East Staffordshire Borough Council Strategic Flood Risk Assessment - Level 2 Report

Addendum

East Staffordshire Borough Council

October 2008

Figure 2.1: Area of Branston Village Lying Below 46.57m AOD

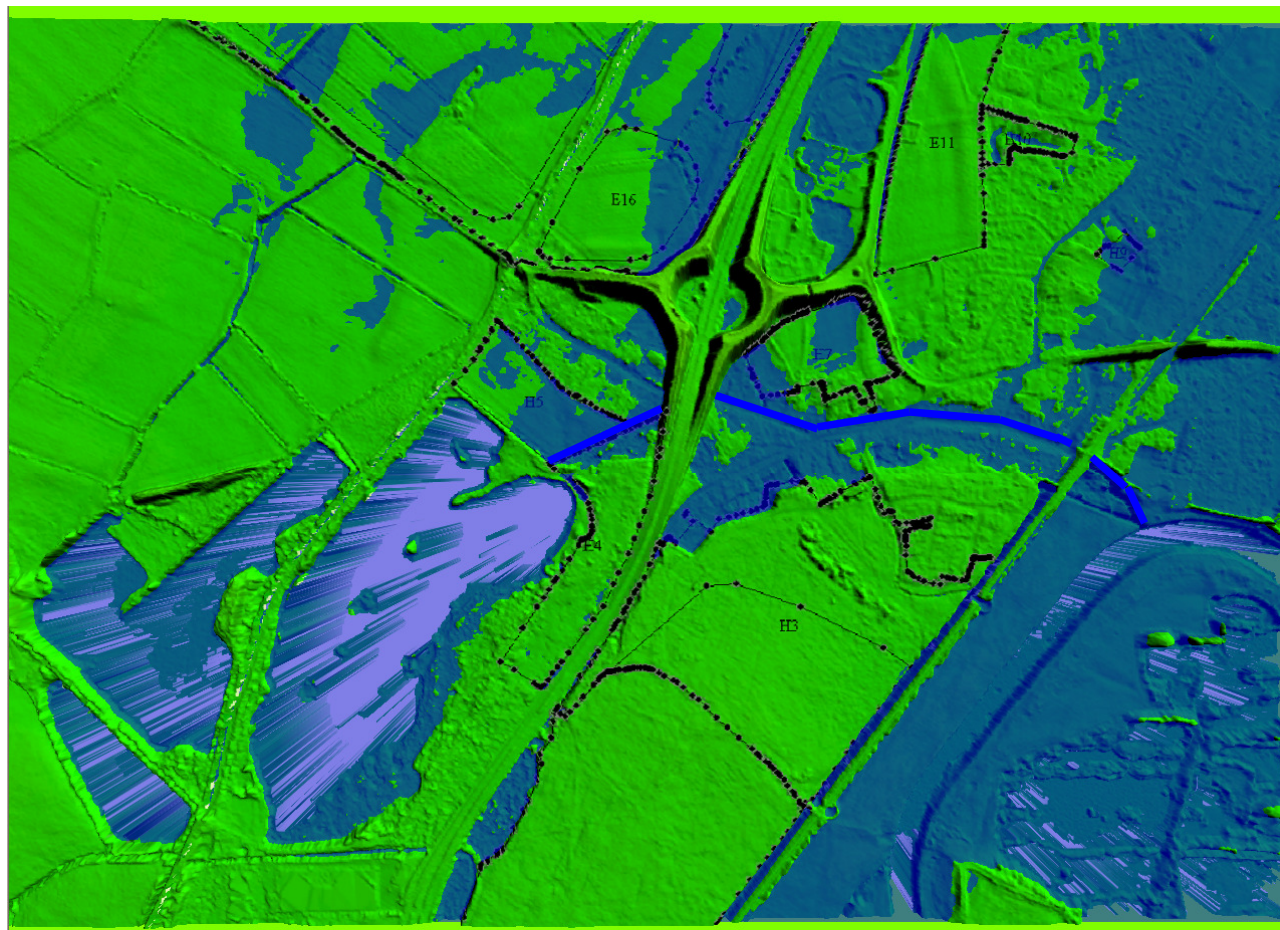
The drainage route in operation from the Branston Water Park beneath the A38 was not previously identified by the Environment Agency and is too narrow to be observed on the LiDAR. It has therefore not been included in the TUFLOW modelling of Burton upon Trent. The Environment Agency is concerned about the potential flooding to the area if the outlet pump on Old Road failed and the drainage route backed up and overflowed as into the low-lying area of Branston Village. To simulate such an event and assess the potential extent of such flooding we have reviewed the LiDAR of the area and overlaid a water depth of 47.57m AOD, as recorded in the 1932 event.

Map figure 8 should show this flooded area together with any other applicable maps. Page 27, 3.3.1.

Figure 2.1 below shows the area within Branston Village which lies below the 47.57m AOD flood level noted by the Environment Agency. The path of the drainage route from Branston Water Park to the River Trent is indicated by the thick blue line. This Figure indicates that parts of development sites H7 and H3 would be affected by such a flood, as would Court Lane and Old Road, as suggested above.

The extent of this flooding must be borne in mind when reviewing the development potential of sites H7 and H3 alongside the other flood risk maps, including both the Environment Agency's Flood Zones and the TUFLOW modelling, included within the Level 2 SFRA report.
